CITY OF ALBUQUERQUE

**RE: 5501 La Colonia DR NW
Tract A Estimates at Taylor Ridge
5501 La Colonia DR NW
Pad Certification dated 10/19/2022
Hydrology File: E12D042**

DRAINAGE AND TRANSPORTATION INFORMATION SHEET (REV 6/2018)

ENGINEER'S SEAL	5501 LA COLONIA DRIVE NW	DRAWN BY WCWJ
DAVID SOULE P.E. #14522	GRADING AND DRAINAGE PLAN	DATE 12-27-21
		2102100110-LAYOUT-12-27-21
		SHEET #
		JOB # 2102100110

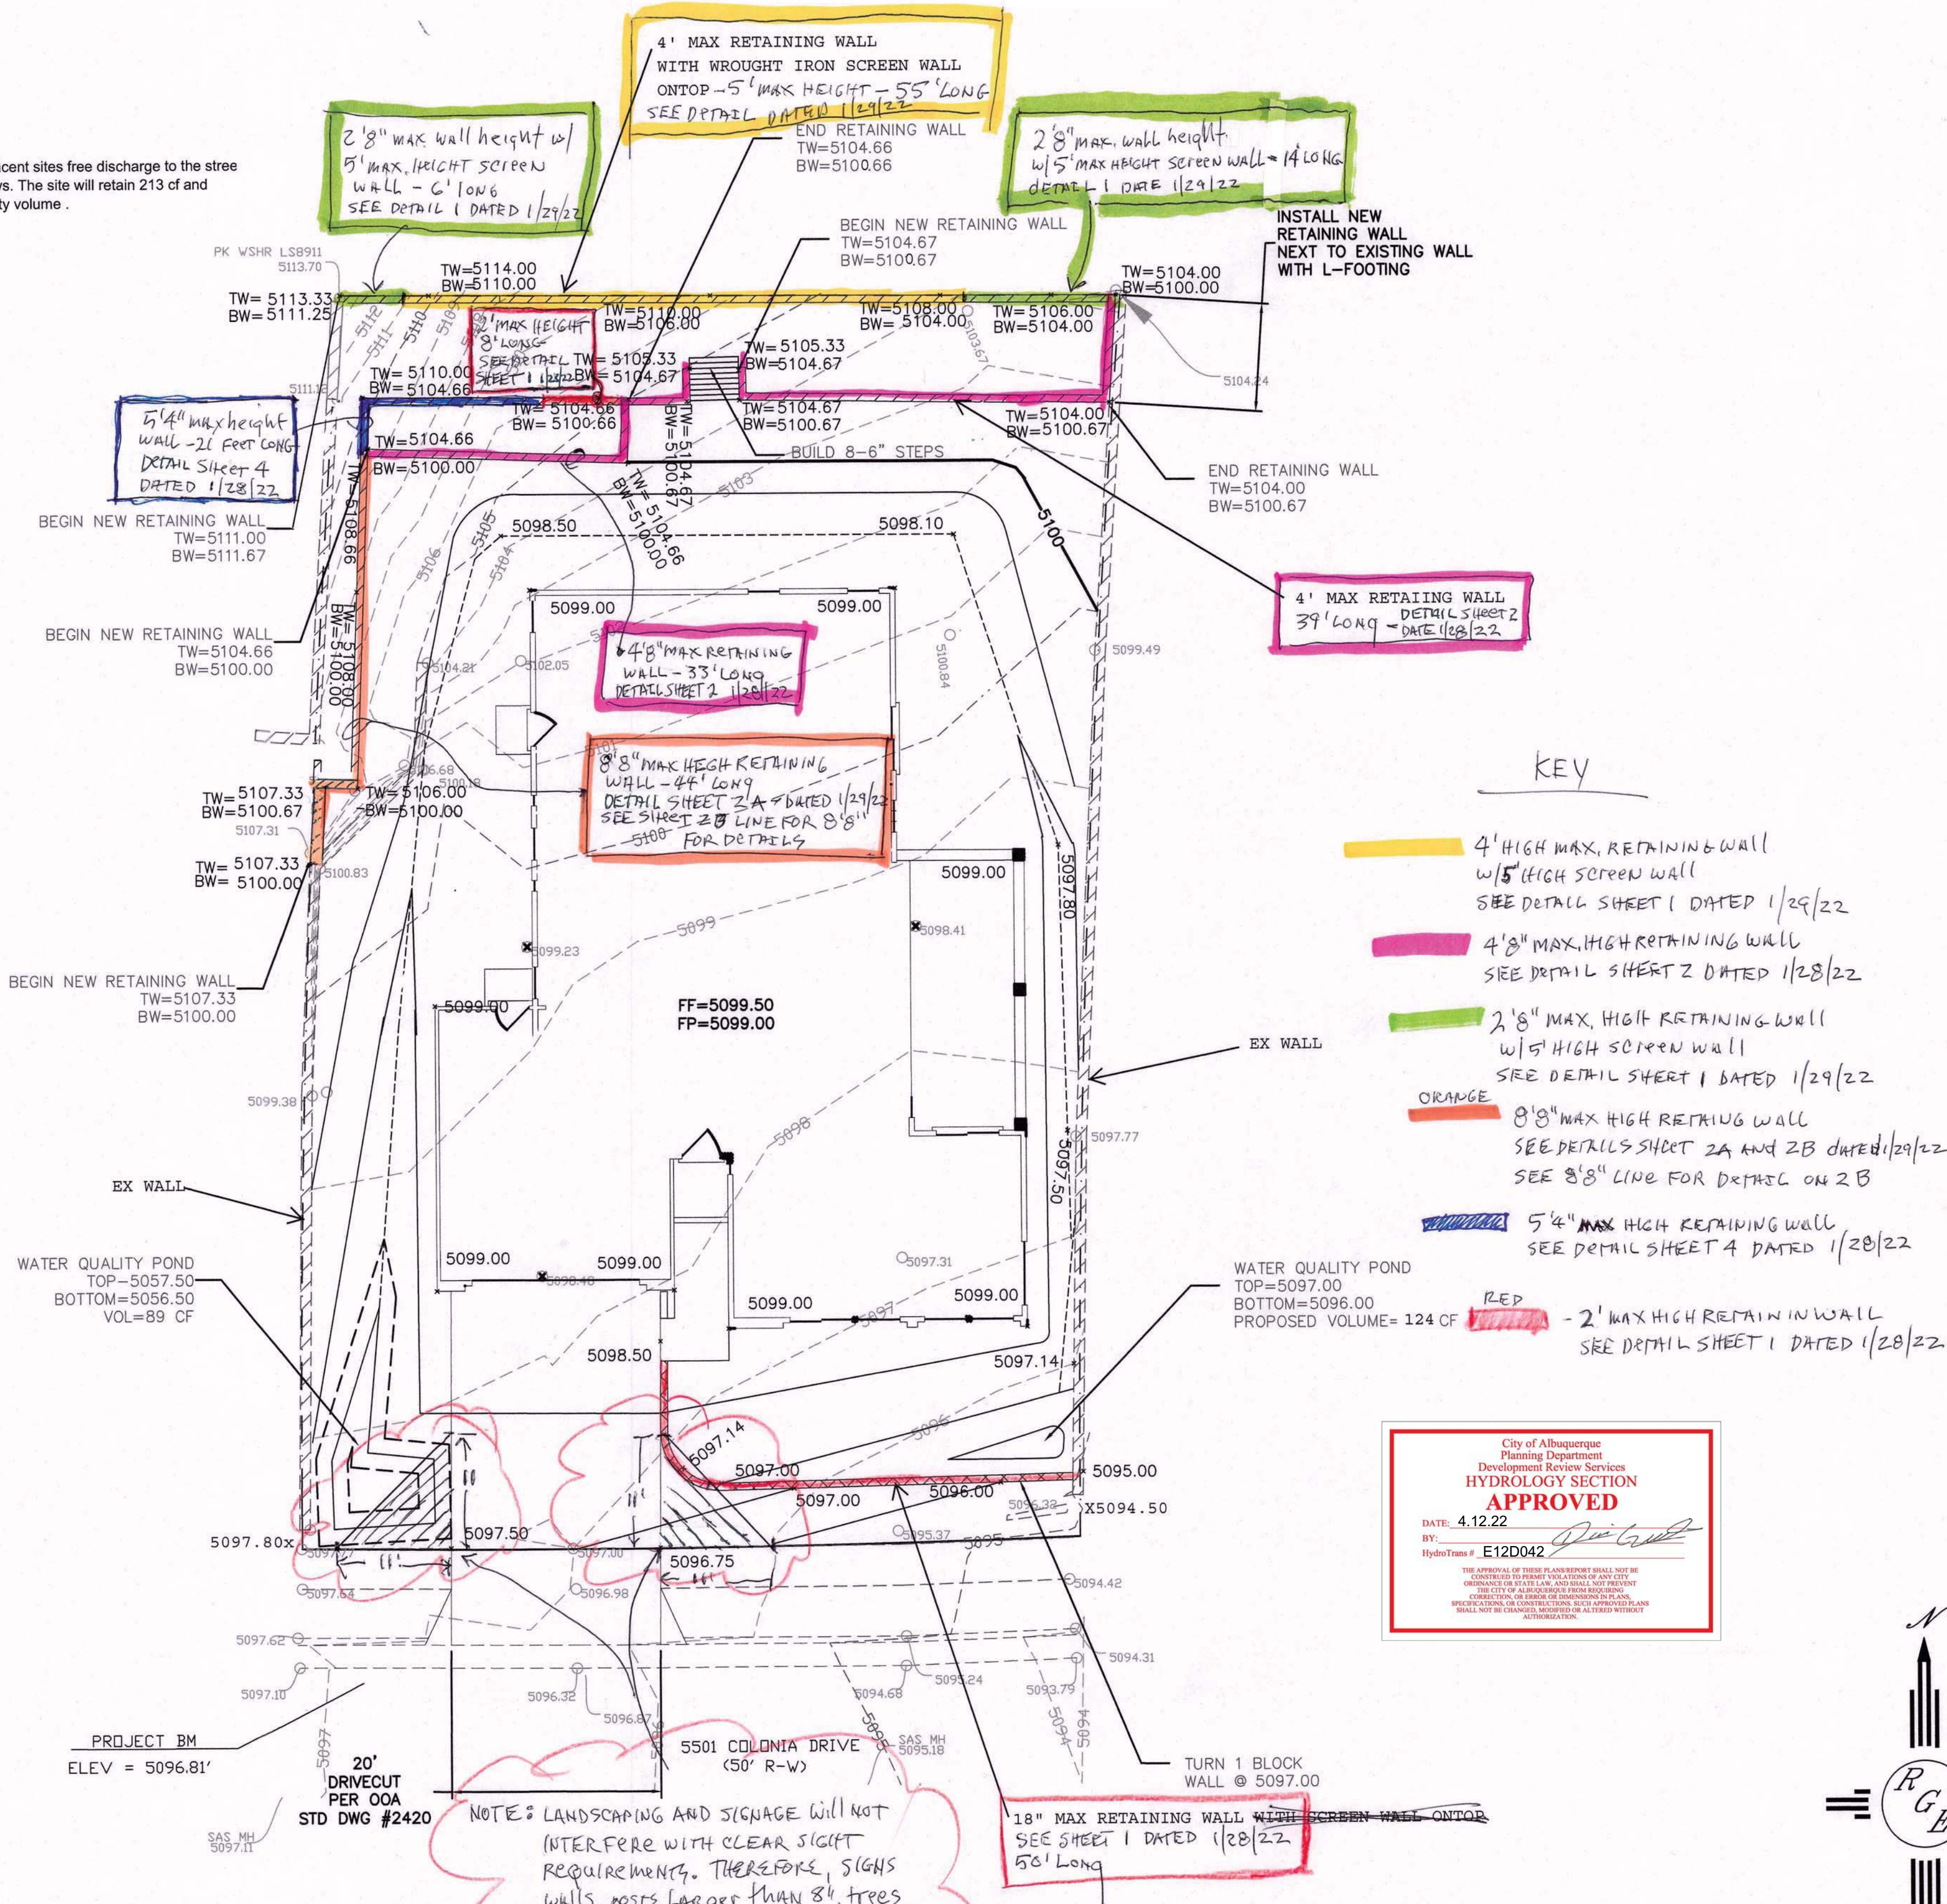
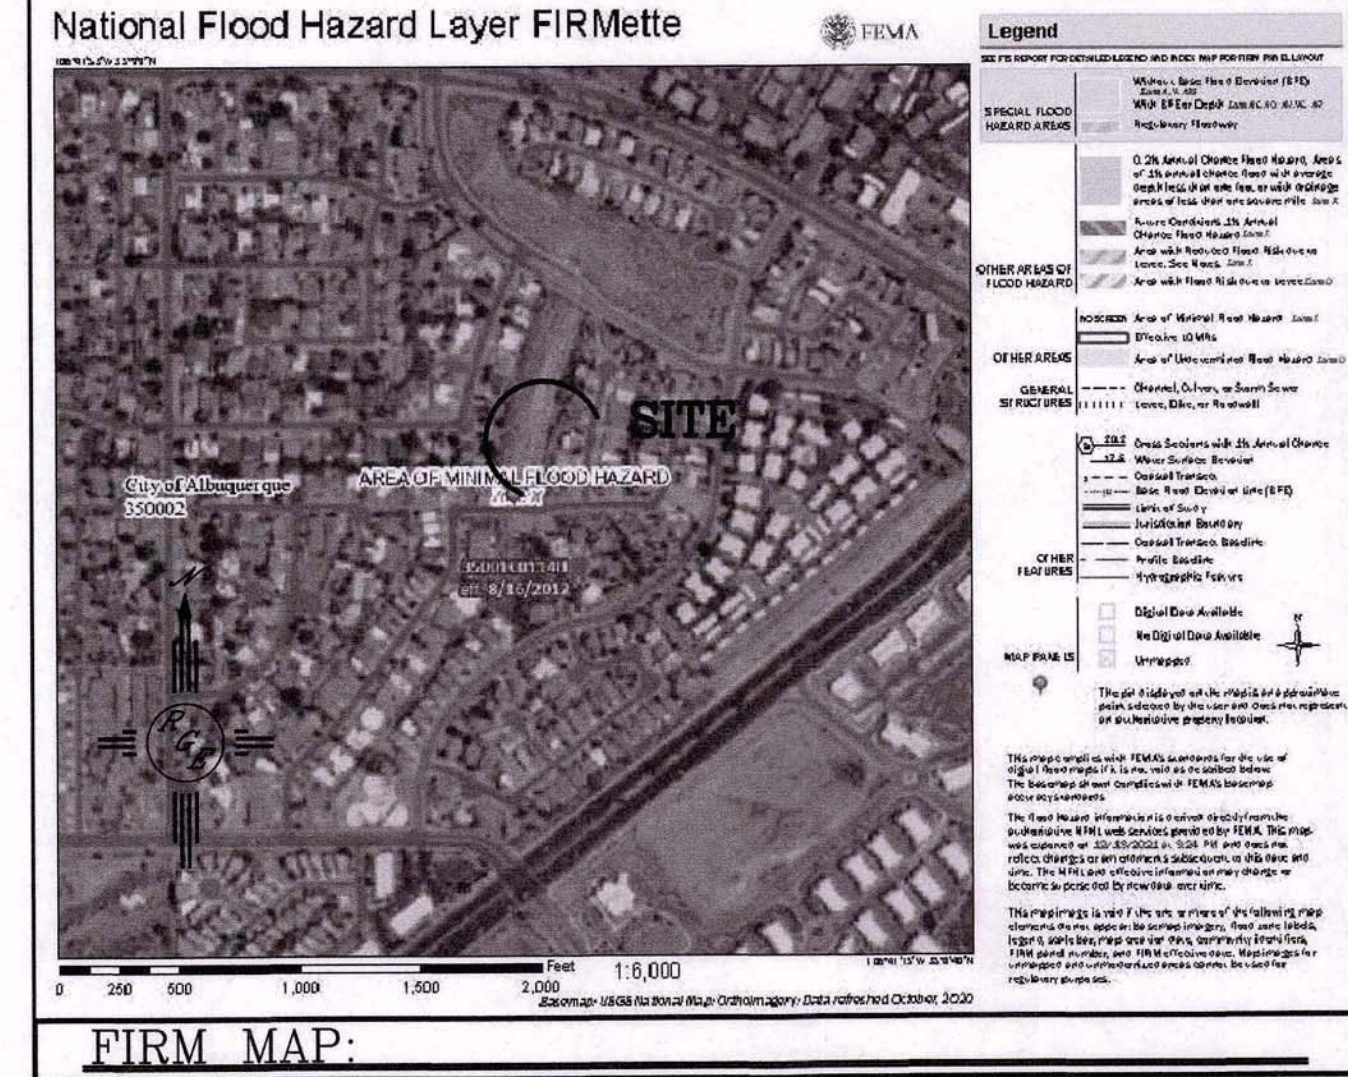
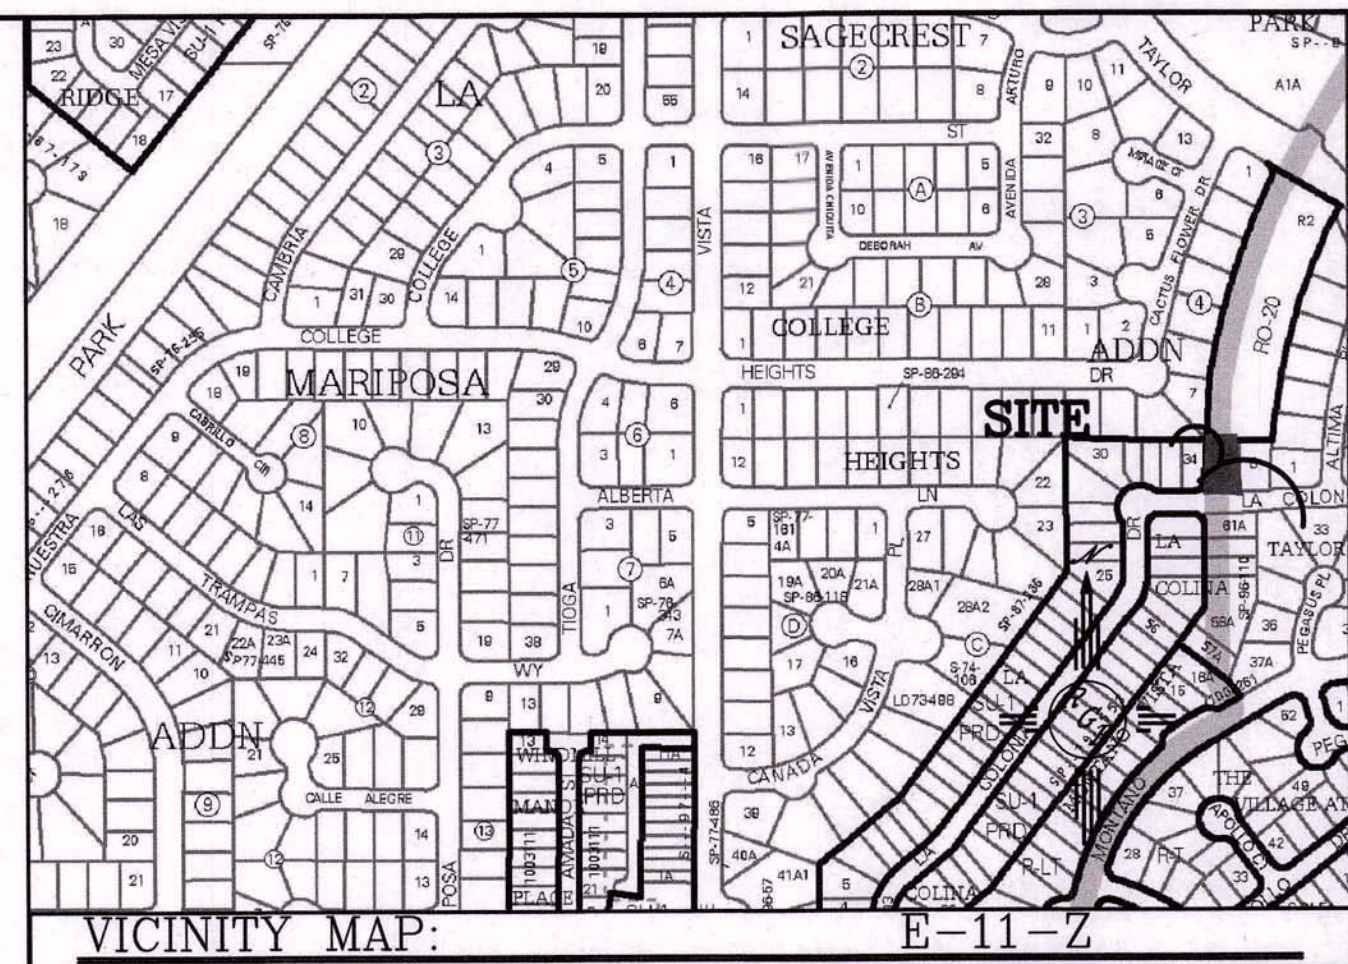
Based upon the information provided in your resubmittal received 10/20/2022, this plan is **approved** for the Building Permit.

Reiterate to the Owner/Contractor that a separate permit for a garden/retaining wall must be obtained, with the approved G&D plan. Also, advise the owner/contractor not to use dirt as a ramp to climb the curb. If dirt is used it will cause a delay in permitting.

Engineer's Certification, per the DPM Part 6-14 (F): *Engineer's Certification Checklist For Non-Subdivision* is required.
